**UNITED STATES  
NUCLEAR REGULATORY COMMISSION**

SUBJECT: TECHNICAL REVIEW: HYDRAULIC PERFORMANCE AND EROSION  
CONTROL OF THE PLANNED SALTSTONE DISPOSAL FACILITY  
CLOSURE CAP AND ADJACENT AREA (DOCKET NO. PROJ0734)

# **Technical Review of the Hydraulic Performance and Erosion Control of the Planned Saltstone Disposal Facility Closure Cap and Adjacent Area**

**Figure 2: Conceptual Illustration of the SDF Closure Cap Layers Configuration  
(Figure 8 in WSRC-STI-2008-00244)**

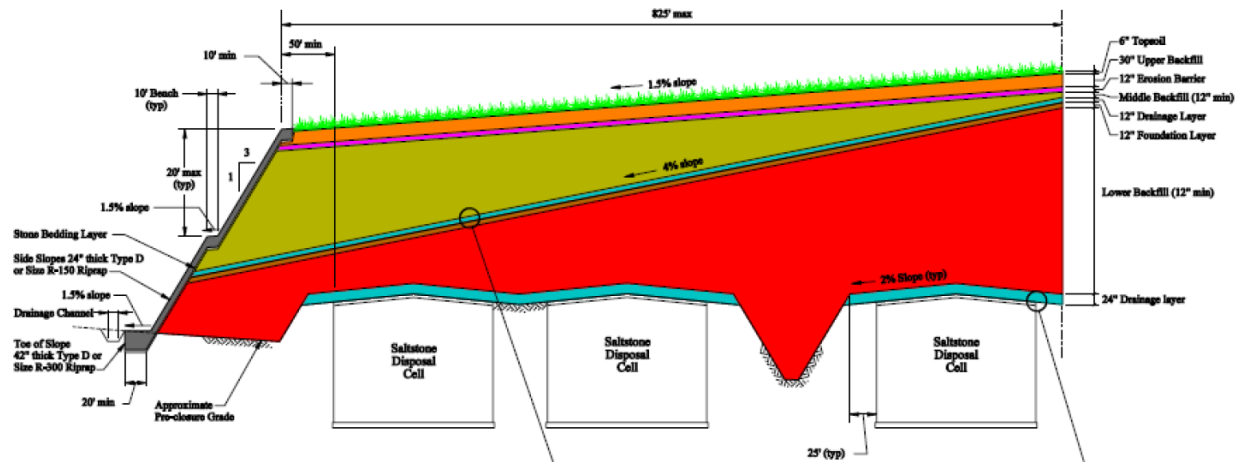
The ability of the cover to reduce infiltration, provide physical stability, and deter intrusion for long time periods is dependent on erosion controls. Erosion control will be necessary to ensure that a thick cover of soil is maintained over the waste for protection of inadvertent intruders and to provide suitable conditions for the vegetative cover. The current design consists of a minimum of 10 ft [3 m] of material above each disposal structure (see Figure 2 taken from WSRC-STI-2008-00244). Although the DOE does not assume the erosion barrier layer will prevent tree root penetration, or prevent erosion of the topsoil and upper backfill layer, the erosion barrier is designed to limit surface water erosion of the underlying layers. In addition, the DOE expects that the design, construction, and performance of the erosion barrier should prevent direct contact of the waste by potential inadvertent intruders and animal intrusion into the lower layers. Aspects of the closure cap designed to prevent gully erosion and limit soil loss were based on scoping calculations.

The DOE determined the projected long-term topsoil loss according to the Universal Soil Loss Equation for both vegetative cover conditions (i.e., Bahia grass then being succeeded by pine forest). The DOE predicted approximately 1.3 in [3.3 cm] of soil loss for the topsoil and no reduction in the upper backfill layer within 10,000 years (WSRC-STI-2008-00244; Section 7.2). Riprap for the integrated drainage system ditches has not yet been sized due to the early phase of the cover design and lack of a detailed closure cap drainage system layout. Riprap material for the erosion barrier, side slope, and toe of the side slope will be selected from local granite or mylonitic quartzite quarries. In the 2013 SDF Monitoring Plan, the NRC staff expressed concern that if a rock source is not available that can adequately resist weathering, then modifications to the closure cap or assumptions regarding performance of the closure cap, or both, may be needed. Those modifications may be more easily accommodated earlier in the closure process. Although the DOE indicated that the design information was sufficient for planning purposes and that rock sources will be evaluated in the final closure cap design, the NRC staff recommended in the Technical Notes for MF 2.02 in the SDF Monitoring Plan (ADAMS Accession No. ML13100A113) that a preliminary evaluation of rock sources be conducted to provide confidence that an acceptable rock source is available.

**Figure 3: Plot of Historical Rainfall vs. Water Levels in the Z-Area Well ZBG 2  
(Figure FFT-1.3 from SRR-CWDA-2016-00004)**

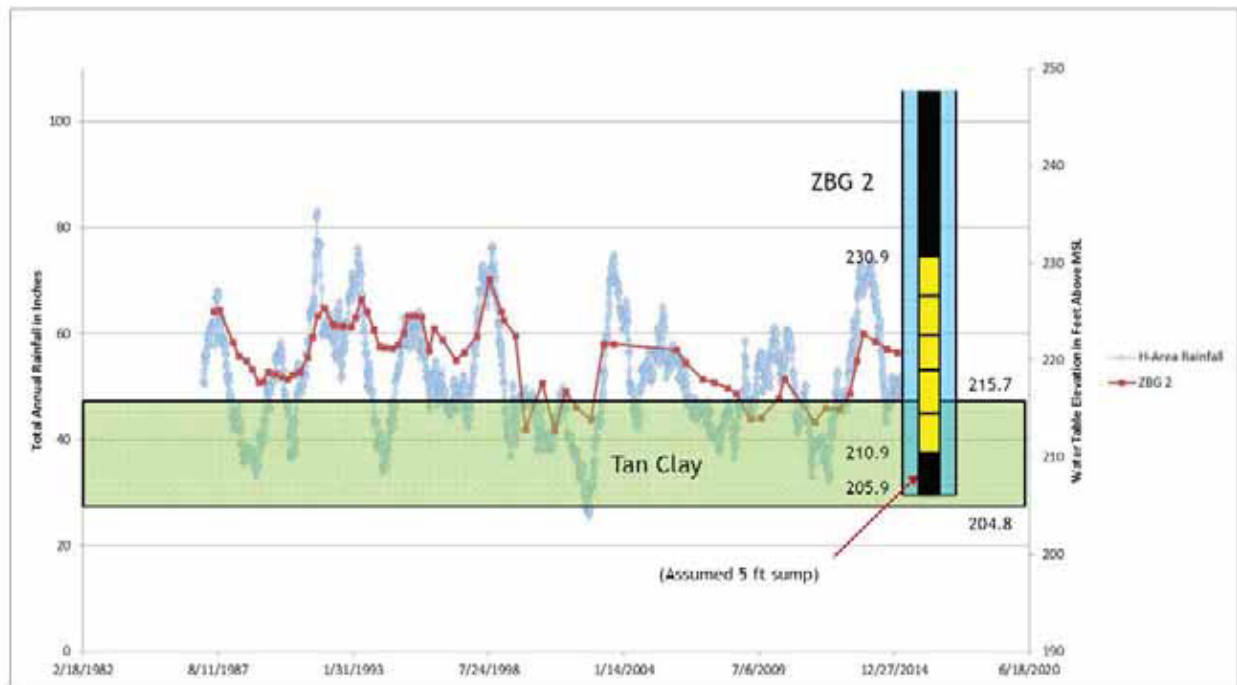
The NRC 2016 OOV report also discussed the DOE sensitivity analyses on precipitation and infiltration rates. The DOE ran multiple simulations with the HELP code using annual precipitation values ranging from a minimum of 29.8 in/yr [75.7 cm/yr] to a maximum of 68.6 in/yr [175 cm/yr]. Sensitivity analyses were described in the 2009 SDF PA and both the FY13 and FY14 Special Analysis Documents using the maximum infiltration value derived from that maximum precipitation value. However, Figure FFT-1.3 from SRR-CWDA-2016-00004

(see Figure 3 below) shows that the maximum precipitation value or the precipitation data set range that is used in the HELP model may need to be reevaluated. Figure 3 below also shows the plot of water levels in Well ZBG 2 in the Z Area versus historical rainfall. It is a comparison of water level readings over time for Well ZBG 2 to the moving one-year average rainfall for the nearest rainfall monitoring station in H Area. The moving one-year average rainfall for the H Area, located less than a mile south of the Z Area, shows averages that lie above the maximum annual precipitation value of 68.6 in used in the HELP model (WSRC-STI-2008-00244, Table 9). In addition, the moving one-year average rainfall for the H Area also lie above the 1964 annual precipitation of 73.06 in [185.6 cm] measured at the combined Savannah River National Laboratory/Central Climatology Site weather stations (WSRC-STI-2008-00244, Table 6) and the 1964 annual precipitation of 71.74 in [182.2 cm] measured at the 200-F weather station (WSRC-STI-2008-00244, Table 7). During the 2016 OOV, the NRC and DOE discussed additional information that might be included in the next revision of the SDF PA. Those possible revisions included updates to the meteorological data used to calculate expected ranges for infiltration in the near future that reflect uncertainty in the current dataset from the last 50 years and also infiltration projections that reflect the uncertainty in future climate states.

**Figure 4: Conceptual Illustration of a Cross-Section from the SDF Engineered Cover Design (Figure 6 [Section B-B' from Sheet 1] in WSRC-STI-2008-00244)**

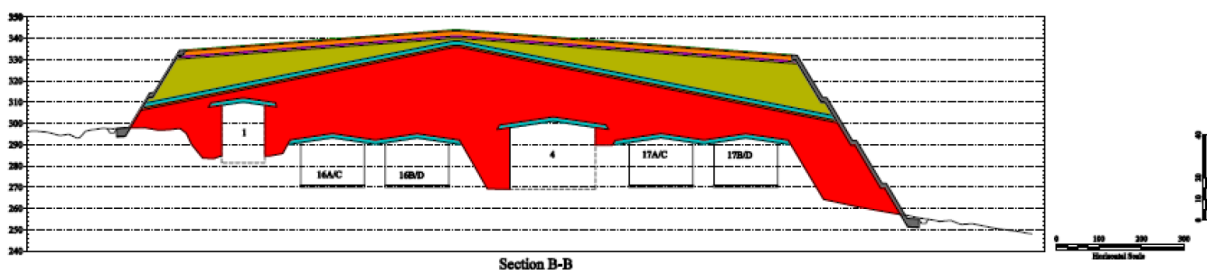
Although the FY14 Special Analysis Document stated that the conceptual design of the closure cap remains unchanged, due to the increased size of the newer 375-ft diameter disposal structures, some type of change to the conceptual design of the closure cap may be necessary

to account for the additional height (i.e., 43 ft (13 m) versus 23.5 ft (7.2 m) maximum internal height) unless the bases of the 375-ft disposal structures are lower in elevation than shown in Figures 6 and 7 in WSRC-STI-2008-00244. The increase in internal height of the 365-ft disposal structures represents an increase of approximately 20 ft (6.1 m), which may require some aspect of the closure cap design to change if any 375-ft disposal structure is to be located close to the perimeter of the closure cap. For example, SDS 7 or SDS 11 will be relatively close to the outer edge of the closure cap based on designs seen in Figure 4. Even if SDS 7 is built at 265 ft (81 m) above mean sea level, the thickness of the lower backfill will likely need to be increased if the slope of the upper lateral drainage layer is to be maintained, and therefore, the height of the side slope would need to be increased. If the conceptual closure cap design is to stay as close to the original design as possible, and if the minimum surface thickness of 10 ft [3.0 m] of non-waste material above the waste material and a minimum thickness of 1 ft [0.3 m] of middle backfill and 1 ft [0.3 m] of lower backfill are to remain, the engineered cover may be higher than previously modeled. If the cover is higher than previously modeled, the side slopes will be higher in elevation and an additional bench may be required. The other alternatives to avoid higher side slopes would be to increase the slope of the upper lateral drainage layer or to increase size or area of the closure cap; the longer the slope, the lower the top part of the side slope will be. Alternatively, the thicknesses of the individual layers could be changed. For example, currently the HELP model and the PORFLOW model have a lower backfill minimum thickness of 72 in [180 cm] over the roofs of the disposal structures. So that the engineered cover does not become too big or too high, a future design could include a thinner minimum lower backfill layer over the cells. However, unless the base of the disposal structures are constructed at sufficiently deeper elevations, all alternatives involve changing the design in some way with the consequence that a majority of infiltration and erosion calculation results as documented in

WSRC-STI-2008-00244 would need to be reassessed and most likely reanalyzed and recalculated. It is possible that the southern part of the closure cap (right side of Figure 5) may not need such recalculations if tall disposal structures such as SDU 10, 11, and 12 as identified in Figure 5 are not built.

**Figure 5: Layout of Disposal Structures (Figure 3.2-2 in the FY14 Special Analysis Document)**

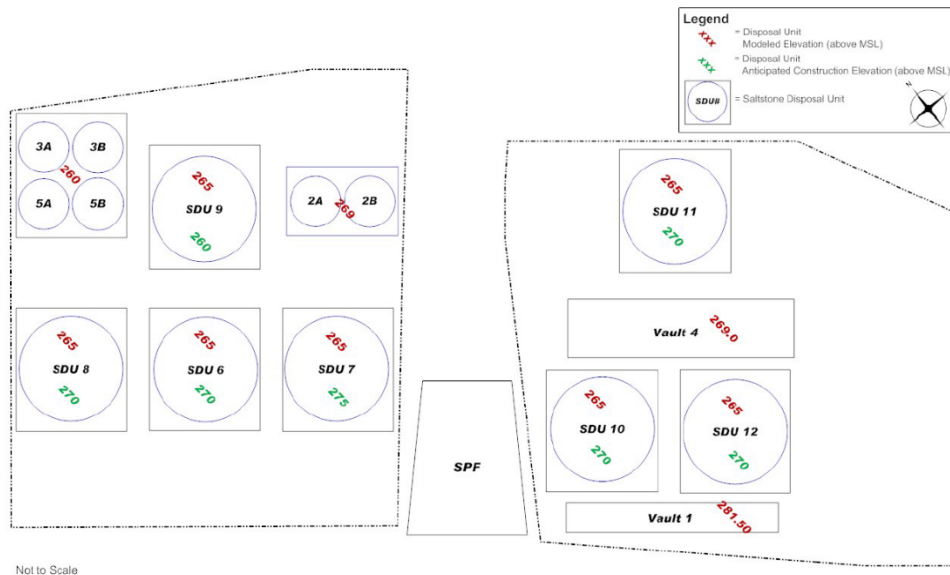
A taller or larger closure cap would require more material, most likely material that makes up the middle and/or lower backfill. Currently the maximum designed thickness of the middle backfill layer is 20.6 ft [6.28 m], while the maximum design thickness of the lower backfill layer is envisioned to be nearly twice as thick (see Figure 4). If the borrow material that makes up most of the backfills requires some modifications to meet design specification (e.g., sand or clay to increase or decrease the hydraulic conductivity, respectively), then the NRC staff would consider this an important technical modification to the design and would need to evaluate the impact of the size, quality, and location of the source of the borrow area or areas.
